Access Compliance Report

Public Rights-of-Way

(Curb Ramps)

Intersection ID: 10027984	Main Street: HARLINGTON_LN	Cross Street: N/A	Location: SW
ADA ID: E97B57359494	Ramp Type: BlendTrans1	Initial Pass/Fail: Fail	Overall Compliance: No
			Severity Score: 8.75
Codes/Mitigation Info/Possible Solution		Field Measurements/Component Compliance

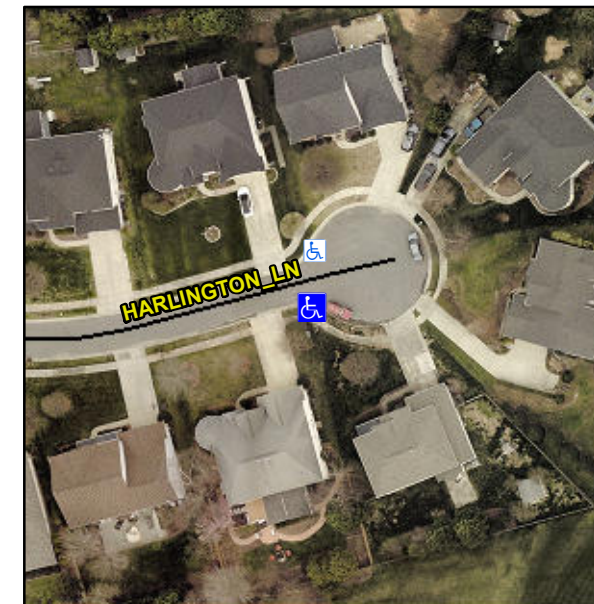
Not Found, R304.5.1

Compliance	Description	Data	Compliance	Description	Data
N/A	Ramp Length (in)	50.0	Yes	BlendTrans Slope (%)	3.5
No	Ramp Width (in)	47.5	Yes	BlendTrans XSlope (%)	2.0
N/A	Flare Type LT	N/A	N/A	Flare Type RT	N/A
N/A	Flare Slope LT (%)	N/A	N/A	Flare Slope RT (%)	N/A
N/A	Flare Traversable LT?	N/A	N/A	Flare Traversable RT?	N/A
N/A	Landing Length (in)	N/A	N/A	DWS Provided?	N/A
N/A	Landing Width (in)	N/A	N/A	DWS Contrast?	N/A
N/A	Landing Slope (%)	N/A	N/A	DWS Length (in)	N/A
N/A	Landing X Slope (%)	N/A	N/A	DWS Full Width?	N/A
N/A	Landing Curb? (Y/N)	N/A	N/A	DWS Offset (in)	N/A
N/A	Shared Landing?	N/A			
N/A	Gutter Ponding?	N/A	N/A	Gutter Slope (%)	N/A
N/A	Gutter Lip Ht (in)	N/A	N/A	Gutter X Slope (%)	N/A
N/A	Painted X Walk1?	No	N/A	Painted X Walk2?	N/A
	X Walk 1 Direction	To N		X Walk 2 Direction	N/A
	X Walk 1 Width (in)	N/A		X Walk 2 Width (in)	N/A
	X Walk 1 Slope (%)	2.3		X Walk 2 Slope (%)	N/A
	X Walk 1 X Slope (%)	2.4		X Walk 2 X Slope (%)	N/A

N/A	Ramp inside XWalk1?	N/A	N/A	Ramp inside XWalk2?	N/A
	Road Slope (%)	2.4		Clear Space?	N/A
	Road X Slope (%)	2.3	N/A	Clear Space to XWalk (in)	N/A
N/A	Any Obstructions?	N/A	N/A	Storm Grate/Utility Hazard?	N/A
	Obstruction Type			Storm Grate/Utility Type	
		N/A			N/A
			Yes	Surface Condition? (G/P)	Good
			No	Curb Slope (%)	13.4

Remove & Replace Curb Ramp With Two New Directional Ramps or Equivalent.
